Barnhill SHD

Stage 1 Road Safety Audit

Document Ref:	P22-091-RSA-PD-RP-001
----------------------	------------------------------

3.1 Problem

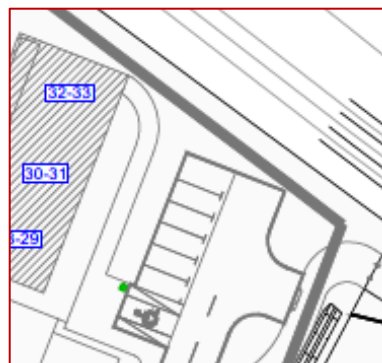
Summary: Unclear if safe vehicular access/egress from parking spaces at the end of cul-de-sac sections of internal roads can be achieved in all instances.

In a number of locations parking spaces have been indicated at the end of cul-de-sac sections of internal roads, and it is unclear from the information provided whether safe vehicular access can be achieved to/from these terminal spaces.

Should there be insufficient room for vehicles entering/exiting these parking spaces, this could result in collisions with vehicles in the adjacent parking spaces resulting in material damage.

The proposed parking spaces within the development should permit safe entry/exit, and the adjacent road layout should accommodate the swept path of the type of vehicles intended to use these parking spaces.

3.2 Problem

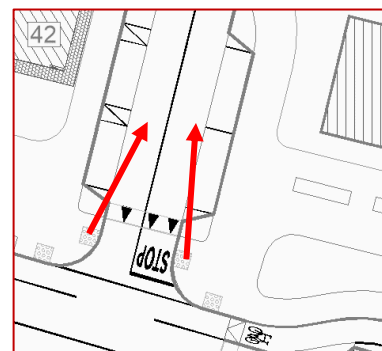
Summary: Edge protection not indicated at the edge of the ditches along the Greenway.

There are existing drainage ditches along the Barberstown Lane North, part of which is shown as being retained for use as a Greenway within the proposed development.

It is unclear if the existing ditches along Barberstown Lane North are to be modified. Should the ditches be retained in their current form, there is a risk that they would present a height-hazard for pedestrians and cyclists on the Greenway, with a risk of personal injury should a pedestrian or cyclist fall into the ditch.

Along the Greenway a review of the existing ditches should be undertaken during the next design stage, and the existing arrangement should be amended if required to remove any risk of falls from height.

3.4 Problem

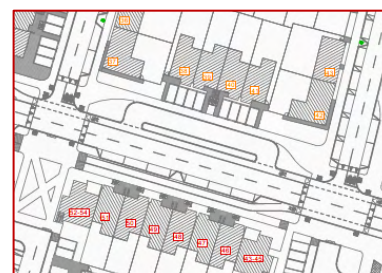
Summary: Visibility at “Link Road West” junction with R149

The access junction to the Link Road West Area is located at an existing side road junction. During the Site Visit it was noted that visibility for vehicles exiting from the existing junction, in both directions along the R149 and in particular to the south, is relatively poor.

It is unclear from the information provided whether it is intended to improve visibility for vehicles exiting at this location. Should the visibility for exiting drivers not be improved, this could result in unsafe exit manoeuvres leading to possible side-on collisions.

Adequate visibility should be provided for drivers exiting at this junction location.

3.5 Problem

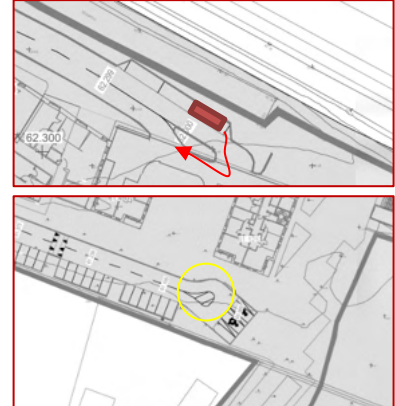
Summary: Approach angle to the junction may result in insufficient visibility to approaching cyclists or traffic.

It is proposed to provide a parallel access road serving Units 38 to 41 within “The Cross” area. The access road is relatively narrow, and it is unclear if this is intended to be a two-way section of carriageway, or one-way.

In addition, it may be difficult for exiting drivers to approach the junction with the Spine Road at an angle close to 90°, which may result in limited visibility towards approaching cyclists or vehicles in one, or both, directions resulting in unsafe exiting manoeuvres and possible side-swipe collisions.

The proposed road layout should be such as to permit exiting vehicles on the parallel access road to approach the junction with the Spine Road at an angle close to 90°. The permitted direction of travel should be clearly indicated to drivers.

3.8 Problem

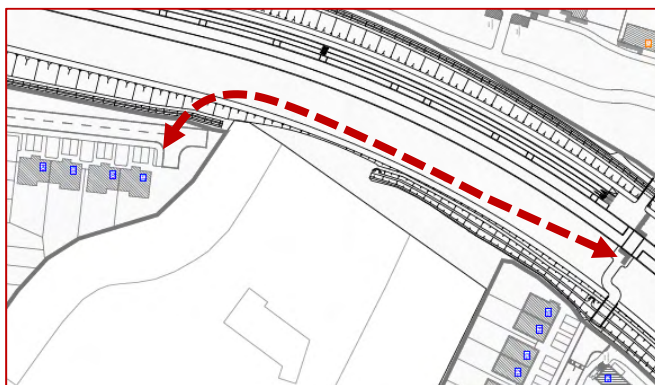
Summary: Limited visibility within proposed undercroft parking may result unsafe exiting manoeuvres.

Visibility for drivers reversing out of undercroft car parking space 11 may be limited by the adjacent wall, resulting in unsafe exiting manoeuvres and possible shunt -type collisions.

Adequate inter-visibility should be provided between drivers of vehicles exiting from all of the proposed undercroft car parking spaces and approaching drivers on the aisles.

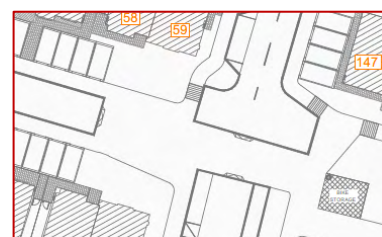
- 4.2 Bevelled Kerbs for cyclist access to/from the shared paths and the carriageways within the development have been indicated at many locations.

At this early stage in the design development it is unclear what the upstand on these kerbs is proposed to be. Should the upstand be too low there is a risk of visually-impaired pedestrians inadvertently entering the carriageway where they are at increased risk of being struck by a vehicle.

During the design development ensure an appropriate height of kerb is provided for cyclist access ensuring visually impaired are adequately warned of the carriageway hazard.
